State of Alaska
Department of Fish and Game
Sportfish Division

Nomination Form
Anadromous Waters Catalog

Region Southcentral USGS Quad(s) VALDEZ C-6
Anadromous Waters Catalog Number of Water Body 212-20-10080-2401-3137
Name of Water Body ☐ USGS Name ☐ Local Name
☐ Addition ☐ Deletion ☒ Correction ☐ Backup Information

Nomination # <u>24-667</u>	<u>Adam Reimer</u> Fisheries Scientist Date <u>3-1-2024</u>
Revision Year: <u>2025</u>	<u>Ron Bentz</u> Habitat Operations Manager Date <u>5/1/2024</u>
Revision to: <input checked="" type="checkbox"/> Atlas <input checked="" type="checkbox"/> Catalog	<u>Chris L. Lipp</u> AWC Project Biologist Date <u>1 April 2024</u>
Revision Code: <u>C-9, C-7</u>	<u>P. L.</u> GIS Analyst Date <u>5/1/2024</u>

Map #1

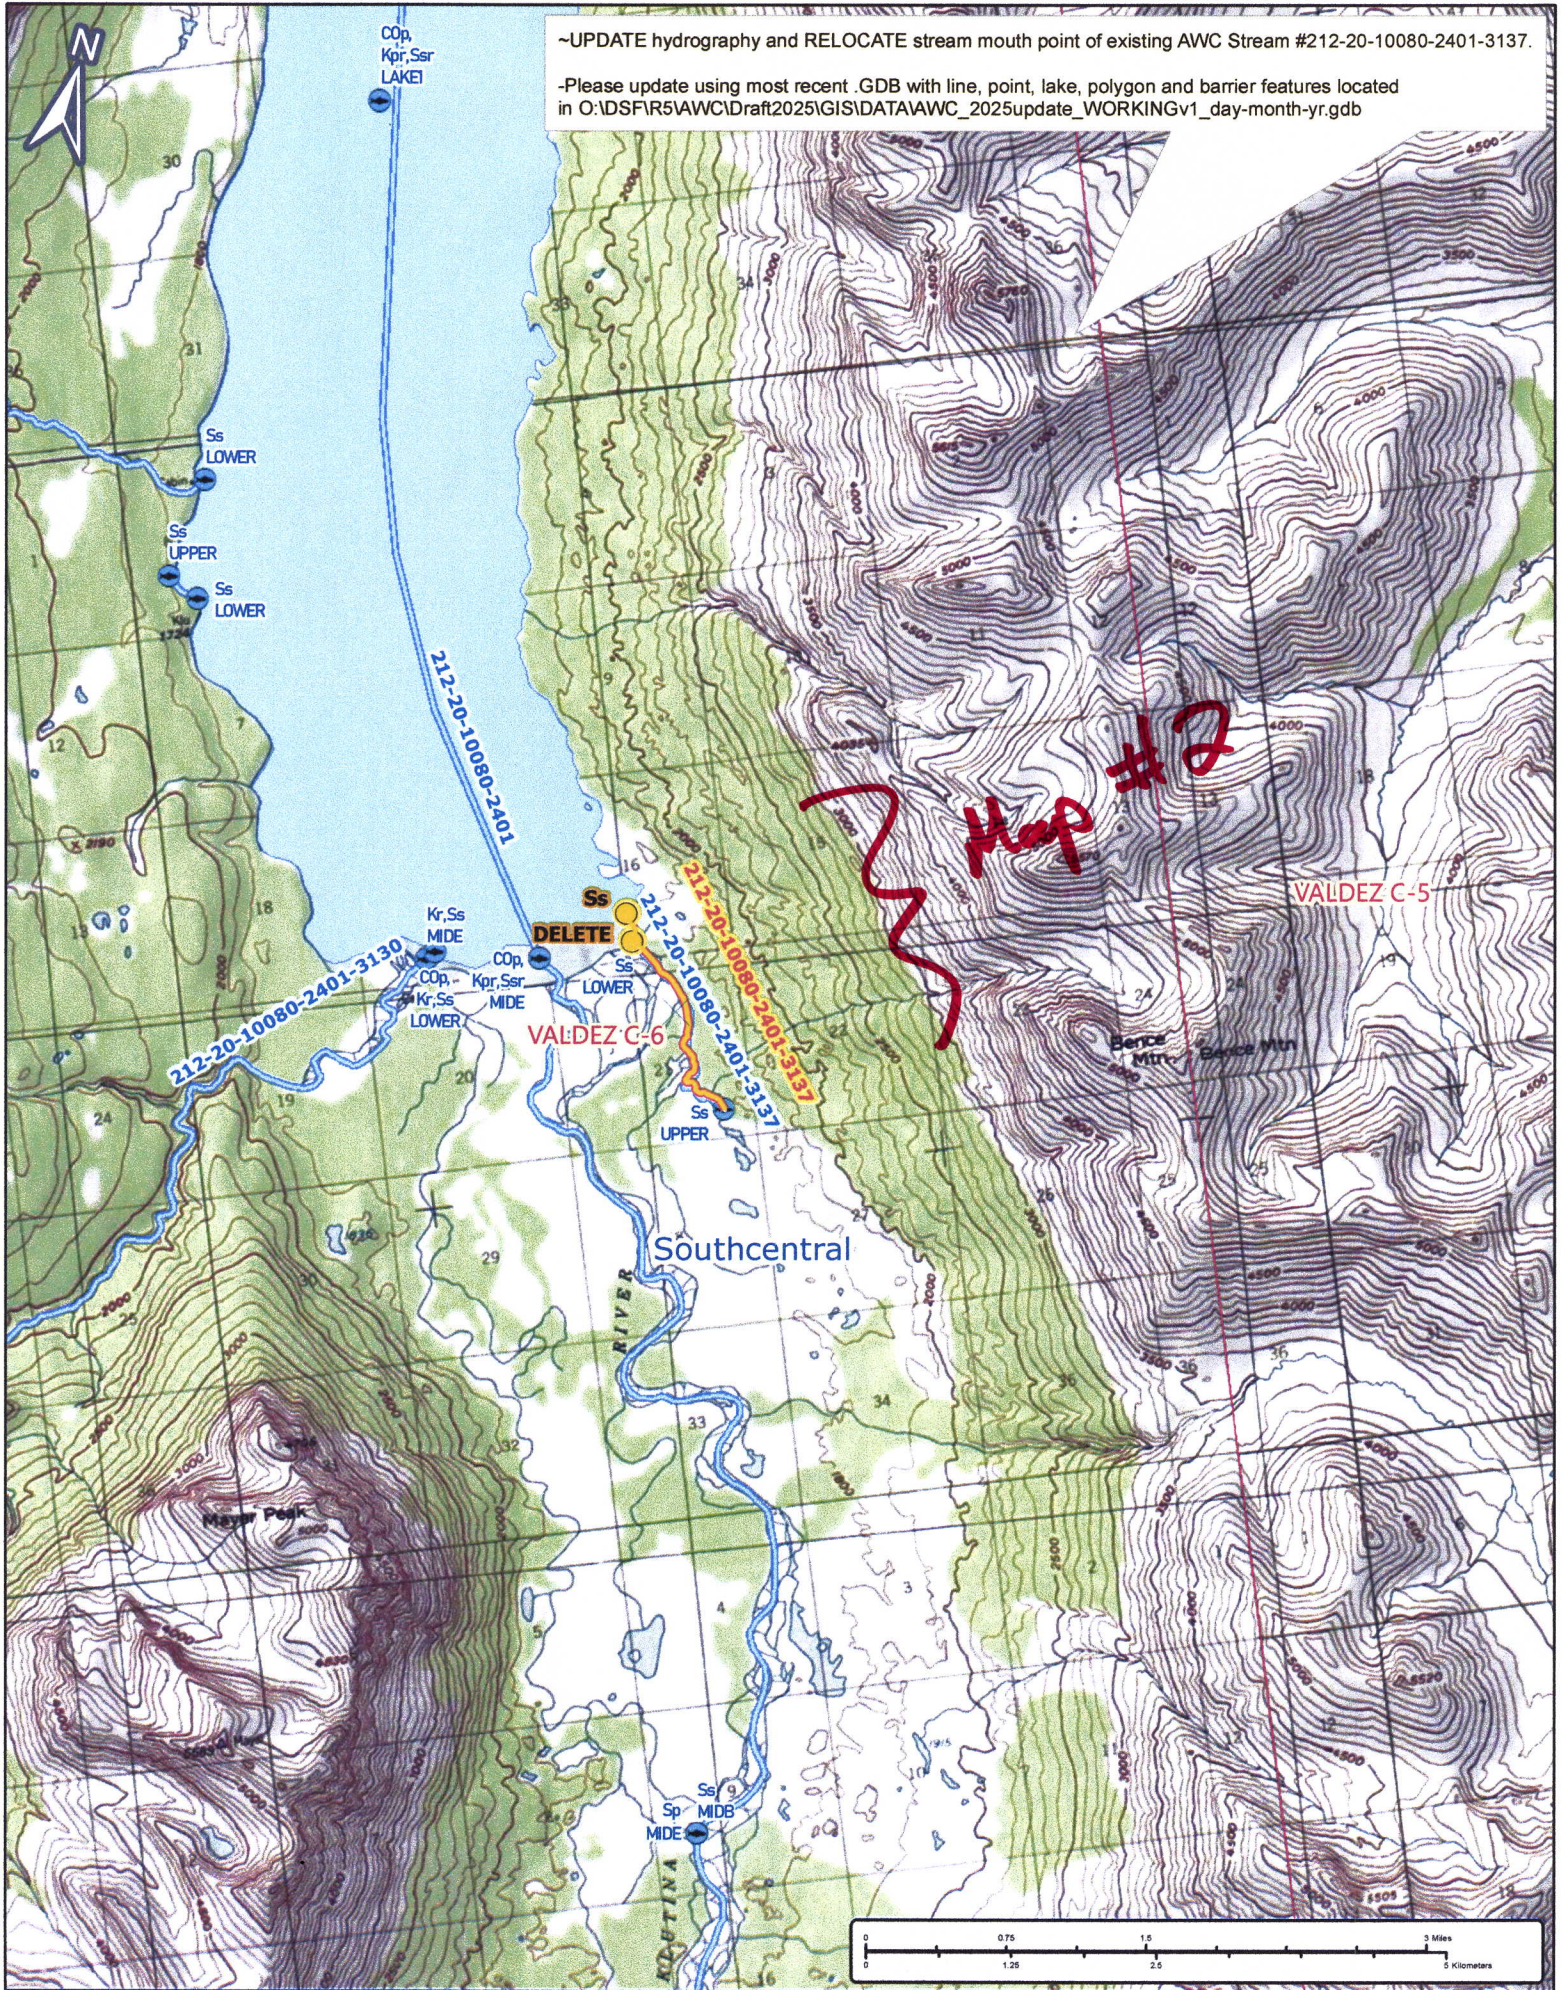
~UPDATE hydrography and RELOCATE stream mouth point of existing AWC Stream #212-20-10080-2401-3137.

Relocate stream mouth point location so it connects to boundary of new Klutina Lake hydrography.

Map #2

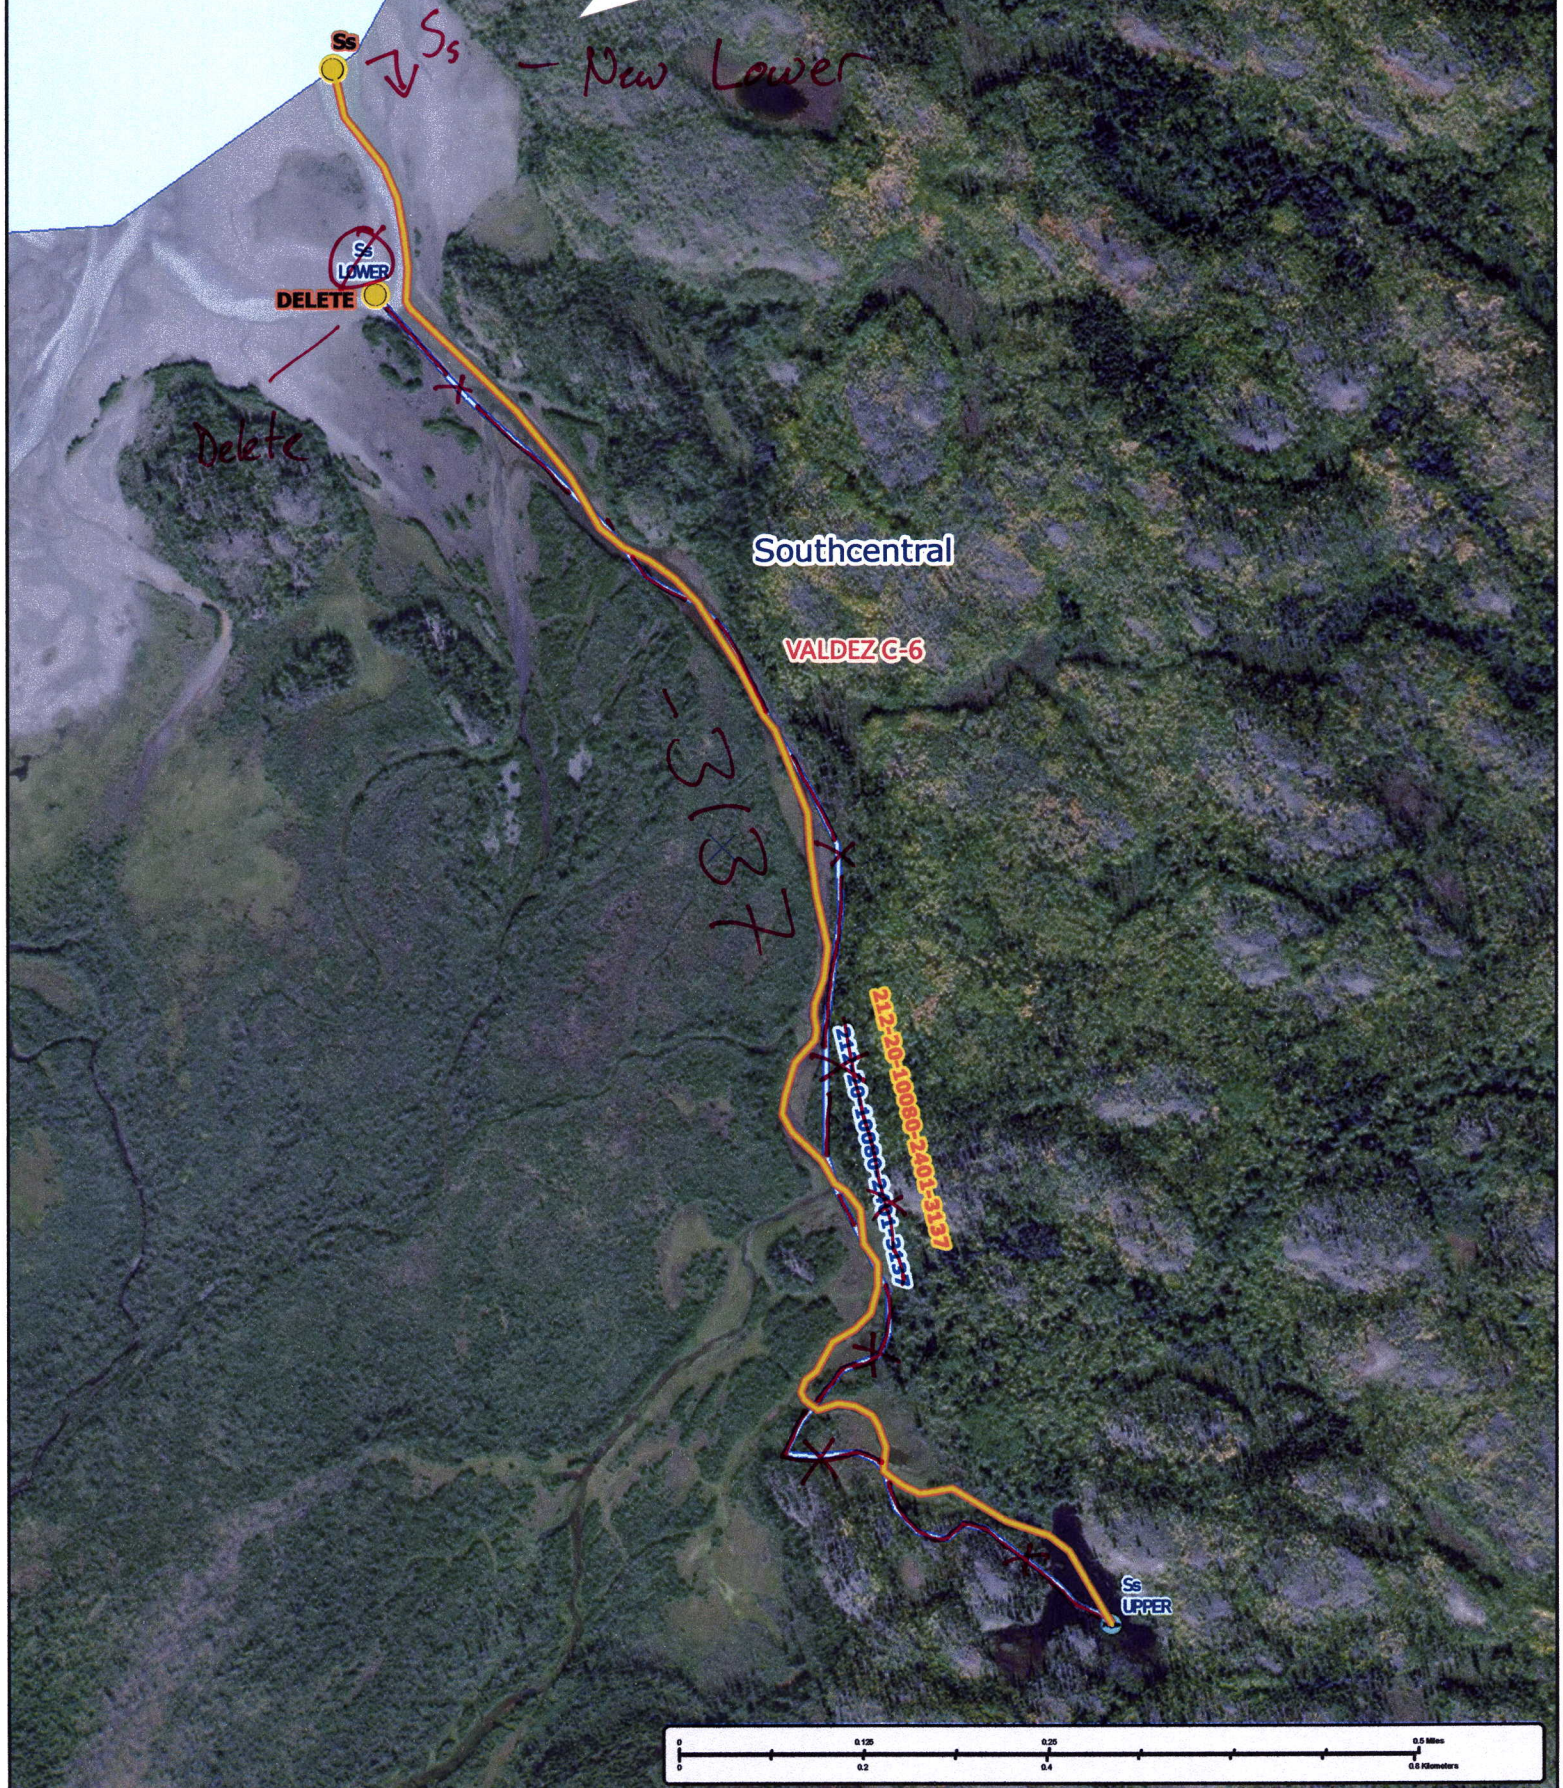
~UPDATE hydrography and RELOCATE stream mouth point of existing AWC Stream #212-20-10080-2401-3137.

-Please update using most recent .GDB with line, point, lake, polygon and barrier features located in O:\DSF\5AWC\Draft2025\GIS\DATA\AWC_2025update_WORKINGv1_day-month-yr.gdb
